TBG II SUBDIVISION

APPLICATION NUMBER 11 DATE February 16, 2012

REQUEST Subdivision

DETAIL SITE PLAN

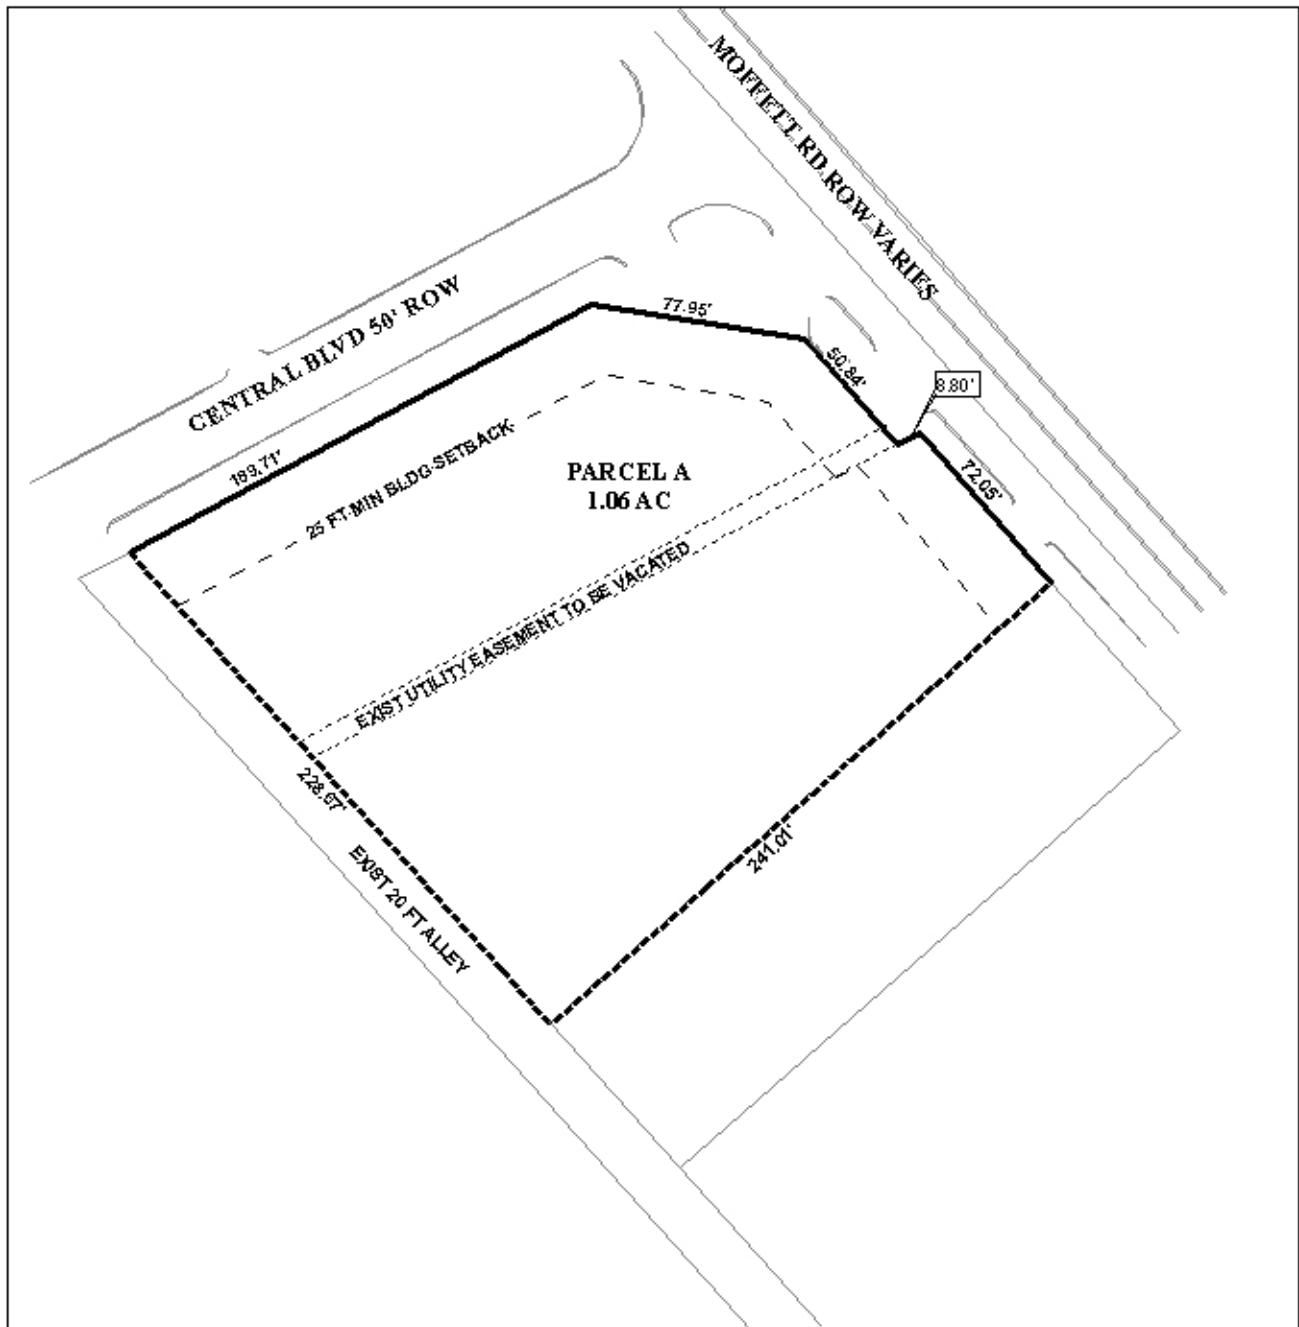
The site fronts onto Central Boulevard and Moffett Road (US Highway 98). Central Boulevard is indicated to have a current compliant right-of-way width of 50' on the plat; therefore, no dedication would be required along Central Boulevard. Moffett Road is a component of the Major Street Plan with a planned 100' right-of-way. As the plat indicates a varying right-of-way width for Moffett Road in front of the site, the plat should either be revised to indicate at least a 50' width from the centerline of Moffett Road currently exists, or dedication sufficient to provide 50' from the centerline of Moffett Road should be required. The 25' minimum building setback line should be illustrated along all street frontages, including the unopened public right-of-way to the rear, adjusted to be measured from any required dedication.

The proposed lot, as depicted, meets the minimum size and frontage requirements as regulated by the Subdivision Regulations. The area of the lot is depicted on the plat, and should also be shown on the Final Plat, revised to account for any required dedication, or a table provided on the Final Plat with the same information, if approved.

As the site is zoned commercially, a note should be required on the Final Plat stating that access to Central Boulevard is denied and the site is limited to one curb cut to Moffett Road, with the size, location, and design to be approved by Traffic Engineering and ALDOT and conform to AASHTO standards. Existing curb cuts should be removed and landscaped to match the existing right-of-way. It should be noted that any curb cuts to Moffett Road, (US Highway 98), must be approved by ALDOT. Should a curb cut to Moffett Road not be approved, a new subdivision application will be required to request a curb cut to Central Boulevard. A note should also be required on the Final Plat stating that access to the unopened public right-of-way to the rear of the site is denied.

A drainage and utility easement is indicated in the middle of the site and noted that it is to be vacated with the recording of the plat. However, the proper process for easement vacations is through a Vacation of Easement initiated with the City Clerk's Office. A telephone conversation with the applicant's due diligence coordinator indicates that process is undergoing; therefore, the Vacation of Easement should be completed prior to signing the Final Plat.

- 1) demolition of one of the two structures prior to signing the Final Plat, or approval of a Planned Unit Development to retain both structures on the site prior to signing the Final Plat;
- 2) revision of the plat to indicate at least a 50' width from the centerline of Moffett Road currently exists, or dedication sufficient to provide 50' from the centerline of Moffett Road;
- 3) illustration of the 25' minimum building setback line along all street frontages, including the unopened public right-of-way to the rear, adjusted to be measured from any required dedication;
- 4) labeling of the lot to indicate its size in square feet and acres, revised to account for any required dedication, or the furnishing of a table on the Final Plat providing the same information;

- 5) placement of a note on the Final Plat stating that access to Central Boulevard is denied and the site is limited to one curb cut to Moffett Road, with the size, location, and design to be approved by Traffic Engineering and ALDOT and conform to AASHTO standards;

- 6) placement of a note on the Final Plat stating that access to the unopened public right-of-way to the rear of the site is denied;
- 7) completion of the Vacation of Easement process for the central drainage and utility easement prior to signing the Final Plat;
